# Possible Noise Sources in the PS Modules

M. Johnson  
June 2015

# Mitigating Factors

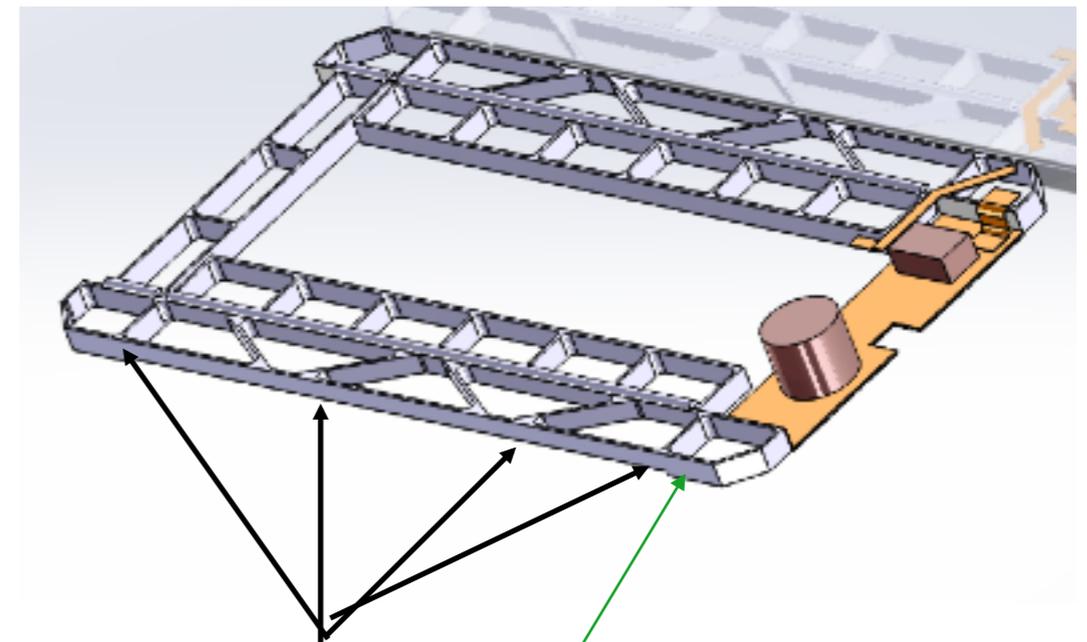
- If the currents are parallel to the side frames, the B field cuts across the strip in the PS 4 design rather than along the strip in the current detector.
  - This almost certainly reduces the magnetic coupling
- High modulus carbon fiber is conducting and the rods will be properly grounded so connecting the PS CF substructure to the rod should provide some additional grounding
